**MULTISITE ROOFING 2019**  
**Sheldon High School**  
**South Eugene High School**  
**Kennedy Middle School**  
**C.I.P. No. 420.780.209**

**ROBERTSON/SHERWOOD/ARCHITECTS pc**  
**132 E. Broadway - Suite 540**  
**Eugene, Oregon**  
**Project No. 1901**

This Addendum forms a part of the Contract Documents and modifies the original Bid Documents dated March 20, 2019 as noted below. Acknowledge receipt of this Addendum in the space provided on the Bid Form. Failure to do so may subject Bidder to disqualification.

**A1**  
102  
1/16" = 1'-0"

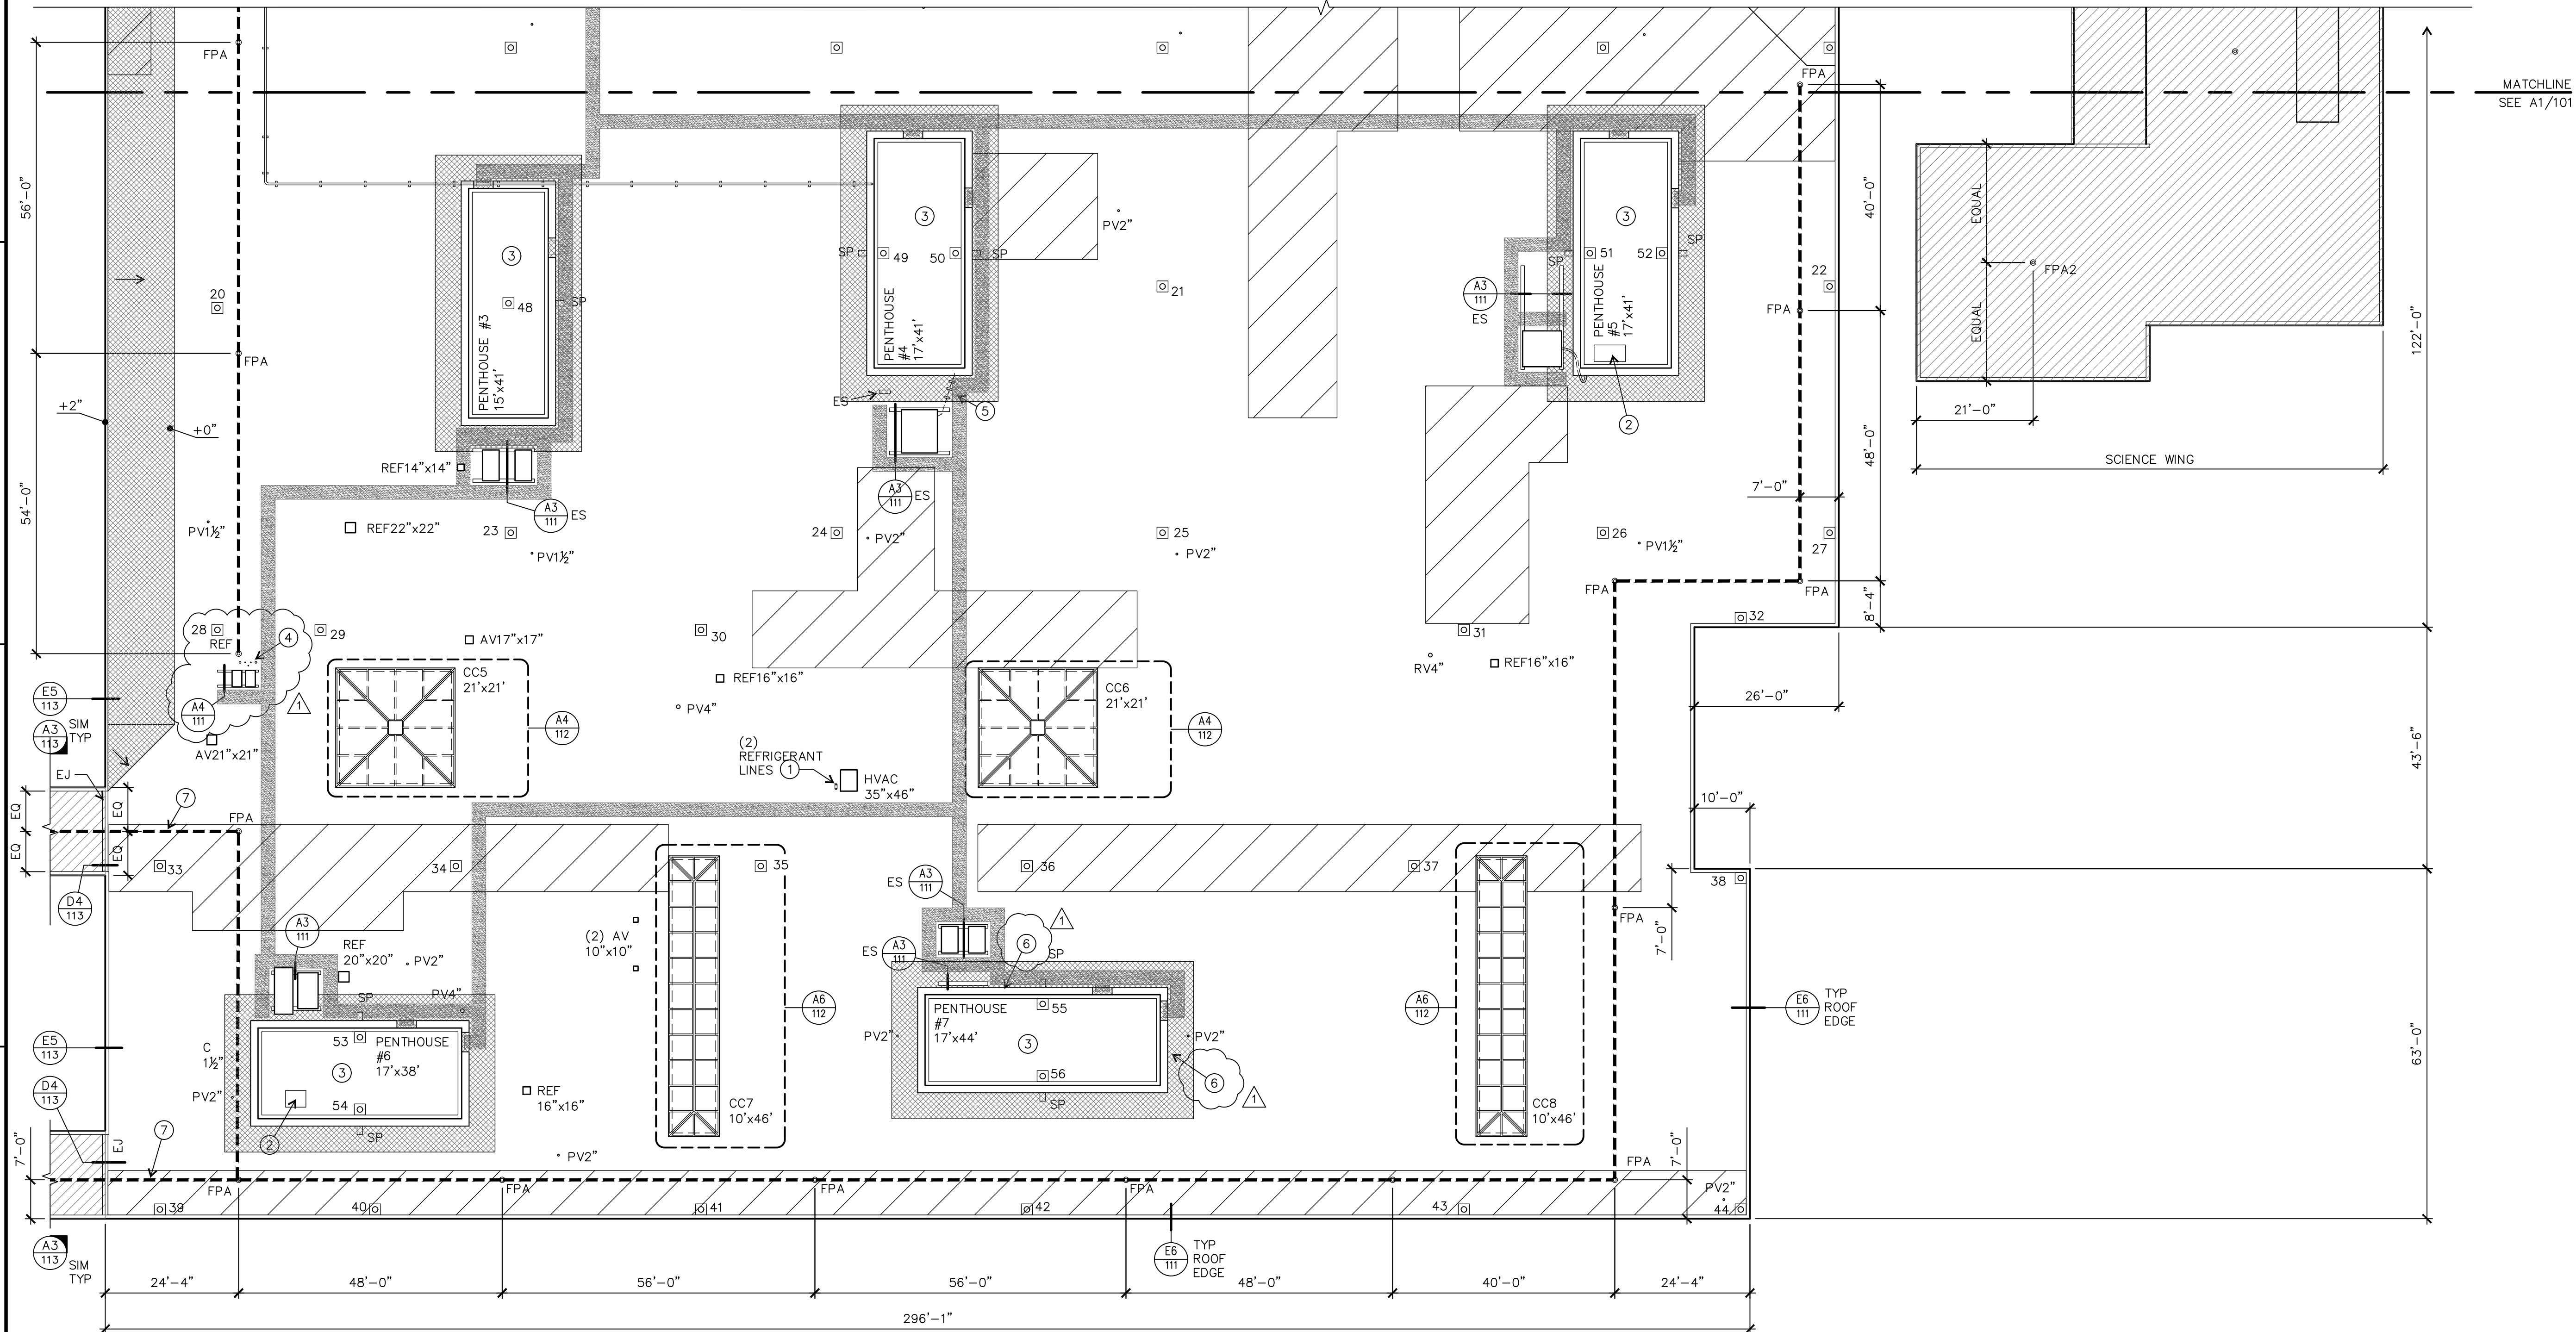
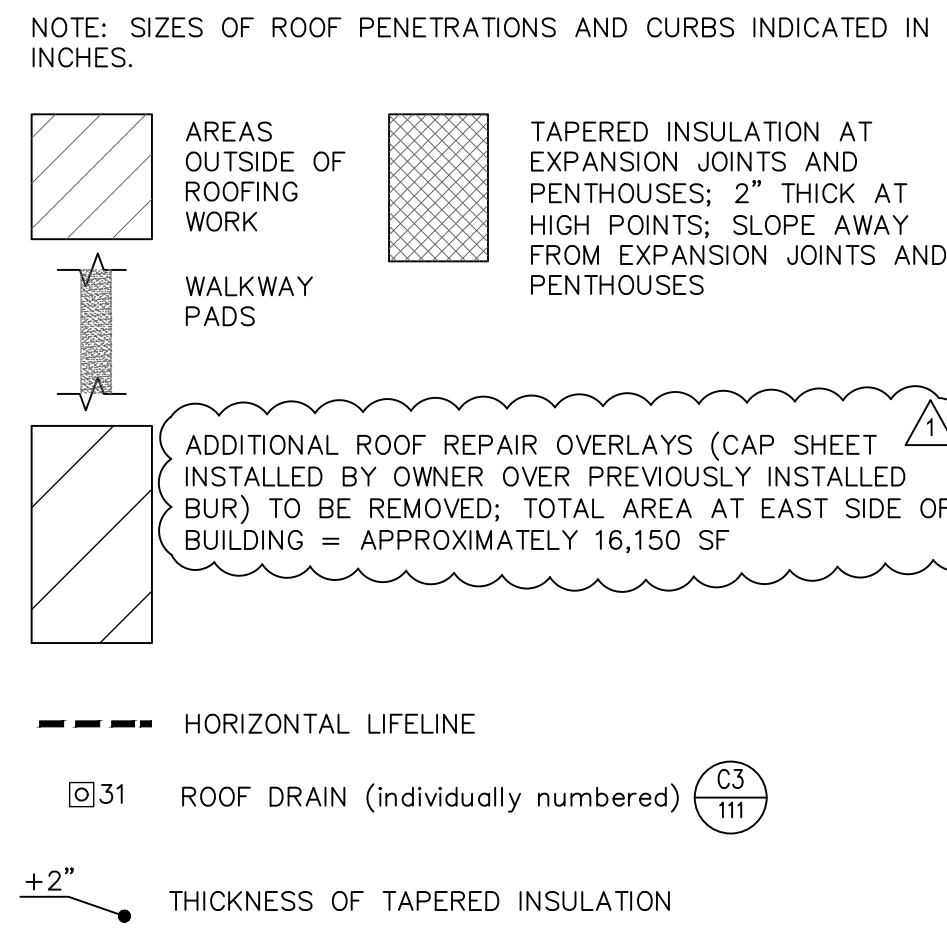
A. Replace Drawing Sheet 102 with new Drawing Sheet 102 attached to this addendum.

Clarification: Drawing is revised as follows:

- i) FPA label added to fall protection anchor near west roof edge.
- ii) Revised detail reference for equipment support curb at high-voltage transformers near west roof edge.
- iii) Keyed Note 6 added and Keyed Note references at Penthouse #7 changed from "1" to "6".
- iv) Clarification made indicating that two sections of horizontal lifelines are to be provided under Alternate No. 2.
- v) Clarification made to Roof Plan Legend that existing roof repair overlays to be removed consist of cap sheet installed by Owner over previously existing built-up roof.

SHELDON HIGH SCHOOL  
 DETAILS  
 BASE BID PACKAGE A  
 & ALTERNATE NO. 1

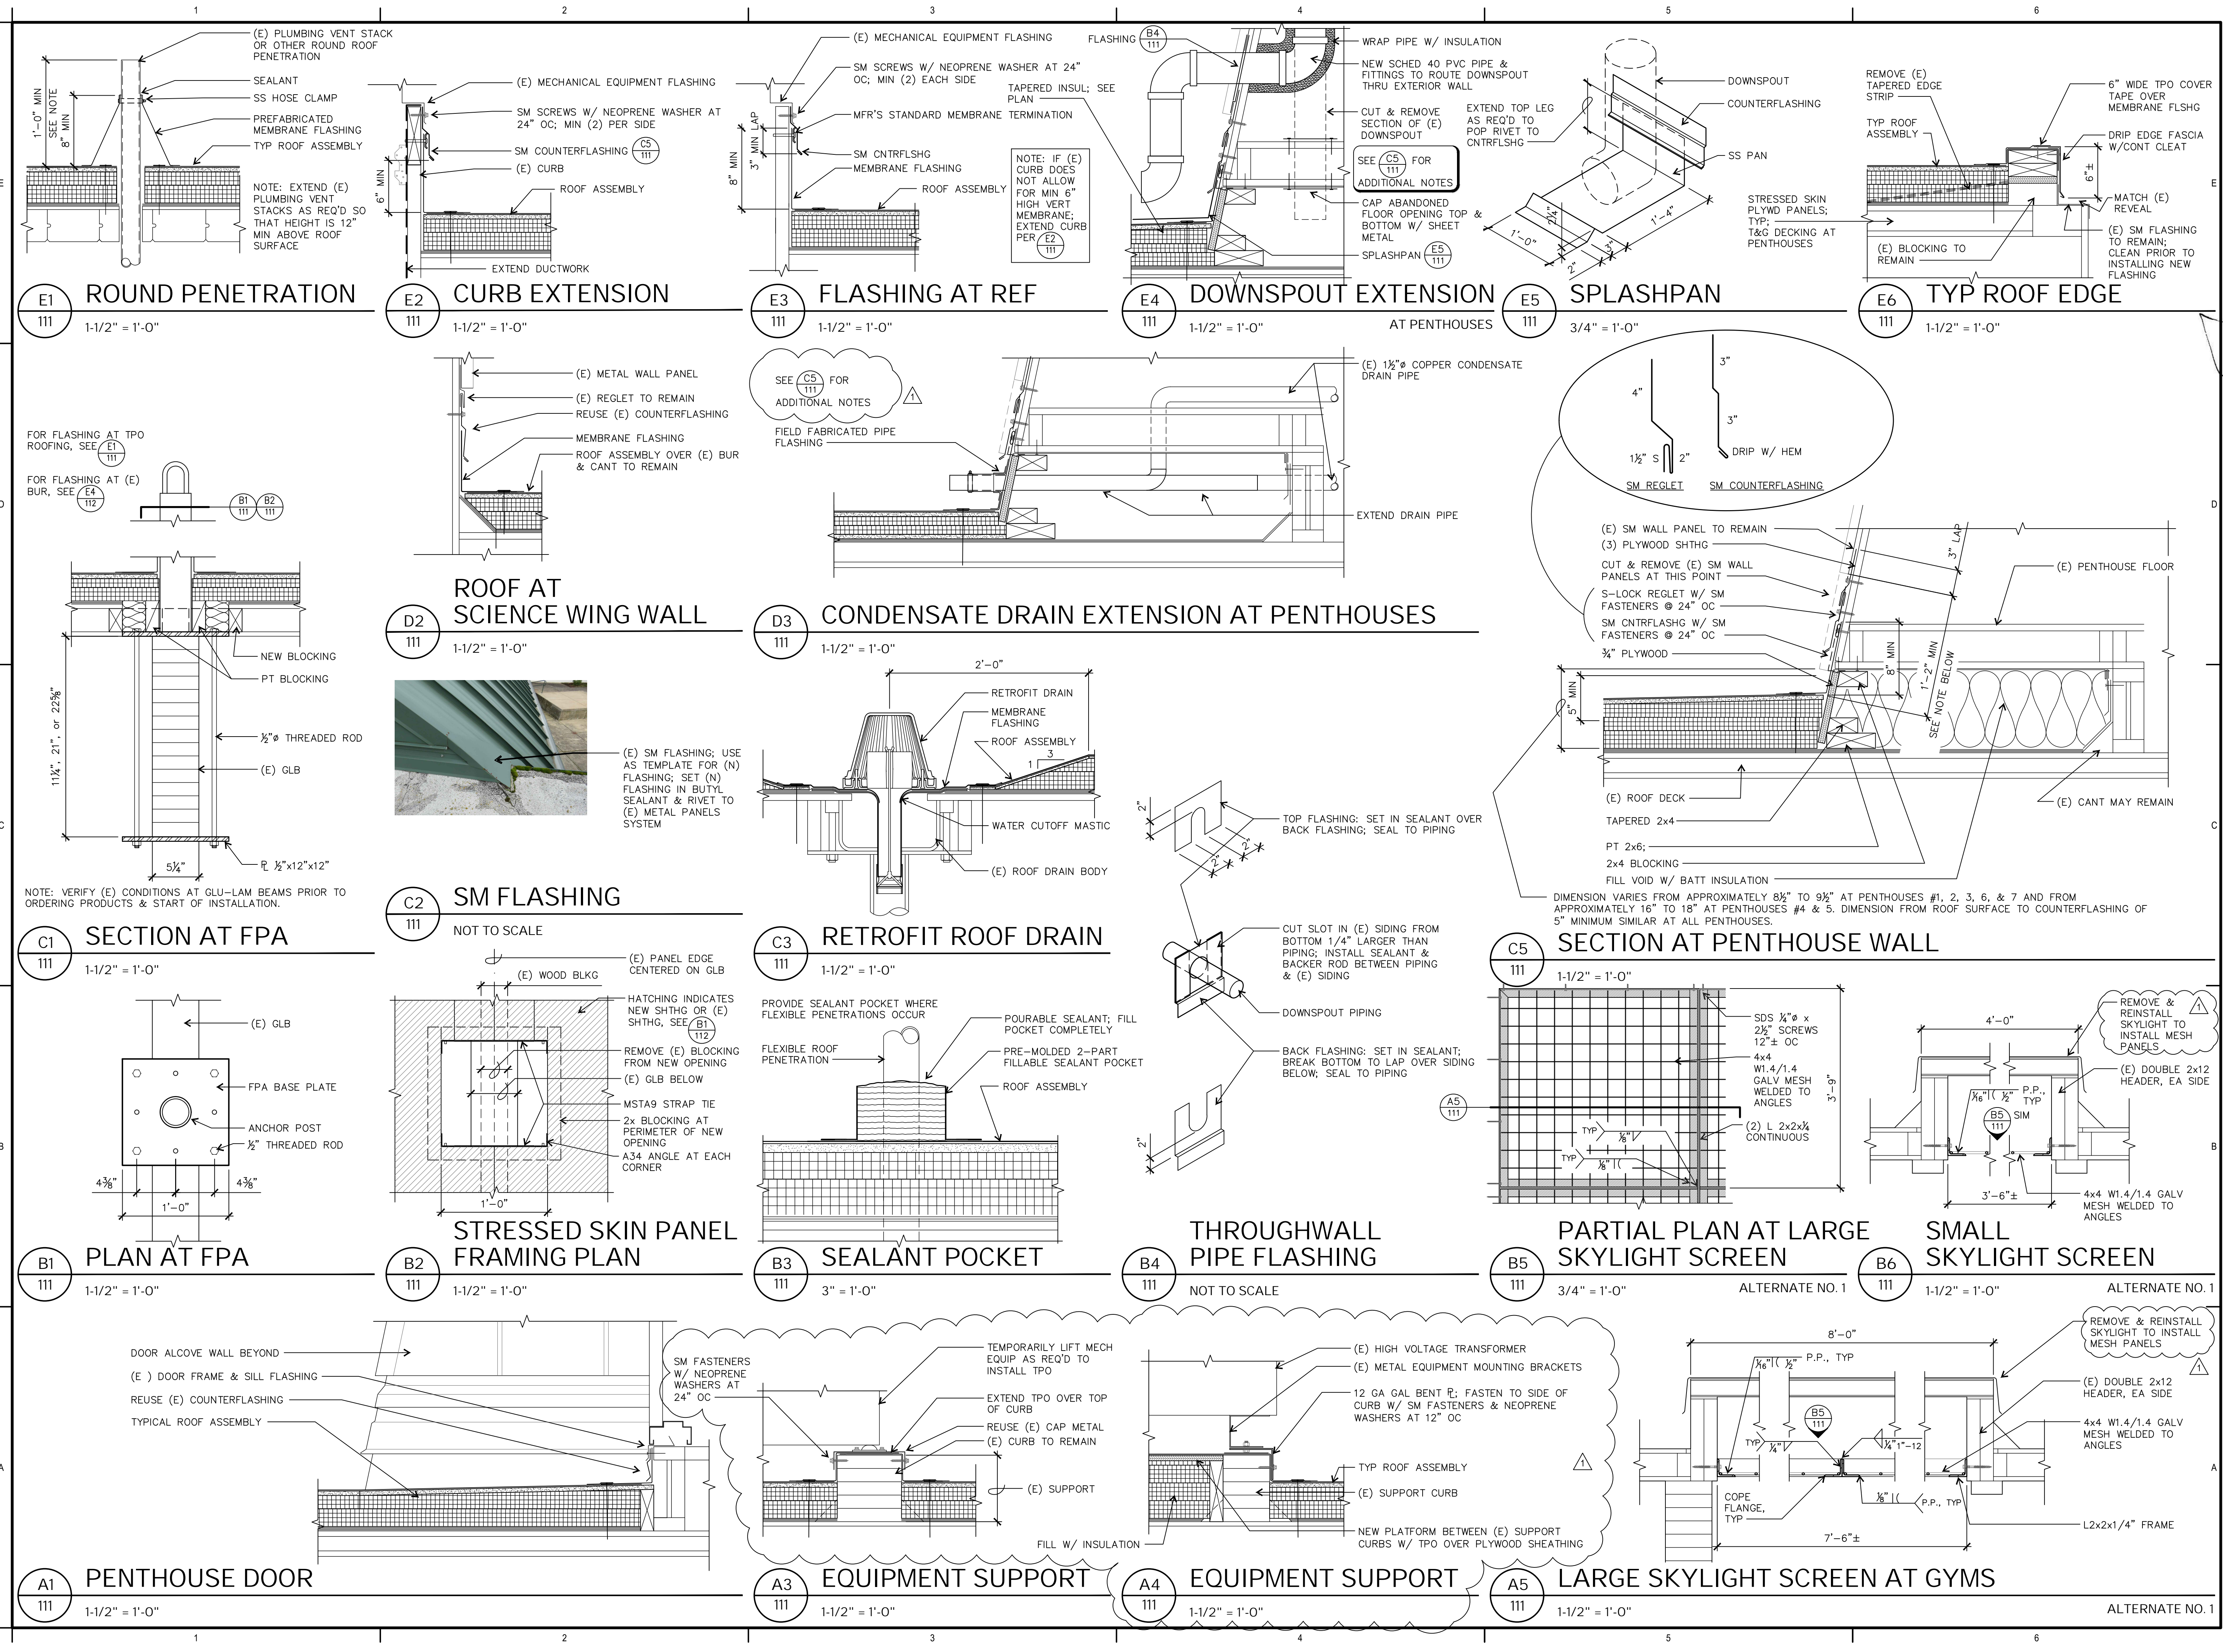
A. Replace Drawing Sheet 111 with new Drawing Sheet 111 attached to this addendum.

Clarification: Drawing is revised as follows:

- i) Detail A3 is modified to so that existing equipment support curbs shall may remain at their current heights.
- ii) Detail A4 is added to show equipment support platform at existing transformers.
- iii) Details A5 and B6, Clarification: Skylights may be temporarily removed to facilitate installation of screen assemblies.
- iv) Detail D3: Detail reference is corrected.
